POLARIS RACE DEPARTMENT

FACTORY COMMUNICATIONS

INFORMATION BULLETIN NO. 1

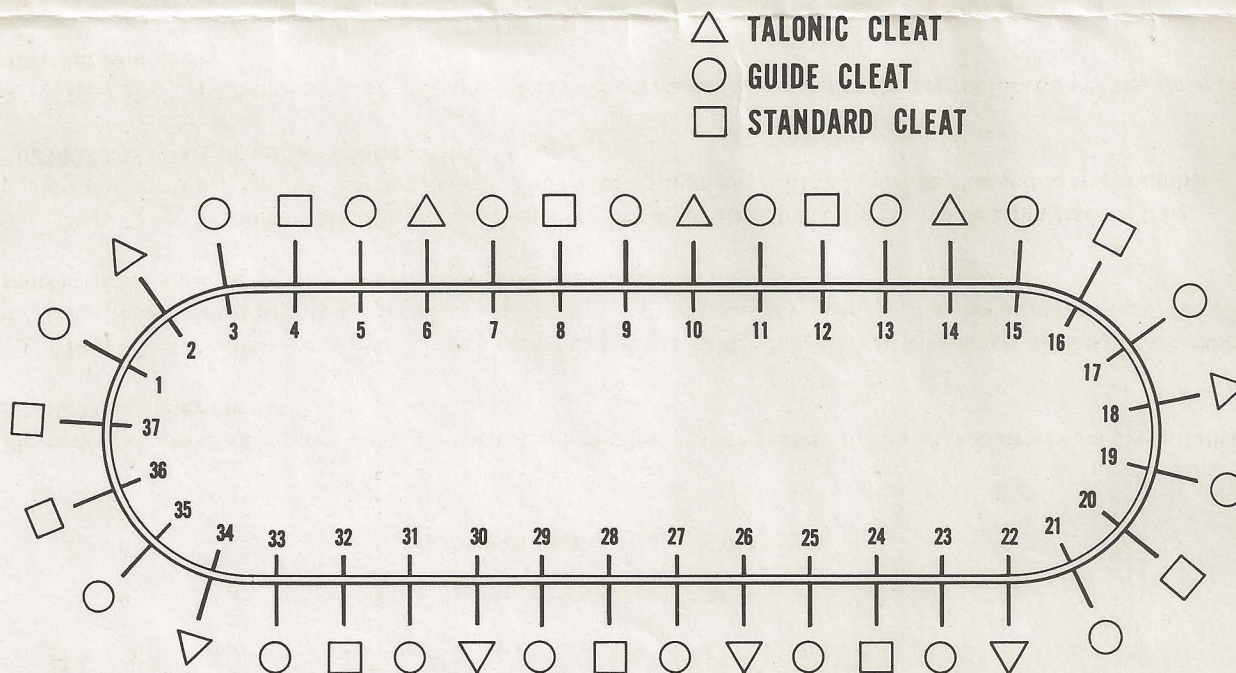
1. Page 15: Technical Manual; Clutch center distance is $10\frac{1}{4}'' +1/8 -1/4''$. Any variance within this tolerance will not effect the shift pattern of the clutch. However, it will be necessary to adjust the gearing accordingly. A shorter center distance requires higher gearing and visa versa.
2. Page 17: Technical Manual: Re: Rivets; For improved cleat/track life the '73' Starfire track will be equipped with a small headed rivet and washer. The rivet part number 7621430 must be changed to rivet number 7621402 and retaining washer number 7558217.
3. Page 17: Technical Manual: Cleats; The diagram shown below shows the proper location of the three (3) different type cleats.

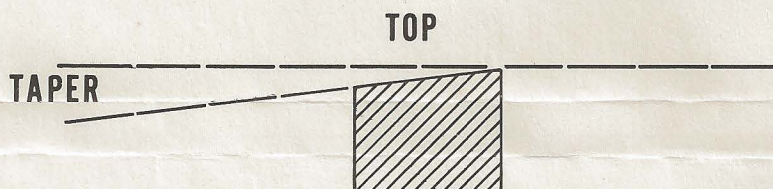
8. Page 38: Item No. 6 — Piston Rings: The 1973 TX Starflame engine will come equipped with "Keystone type" rings. It will be necessary for you to confirm which is the top of the piston ring. This will be difficult to see with the naked eye, so it will be necessary to lay a straight edge on the ring to find the taper. Install ring with the taper up. See diagram.
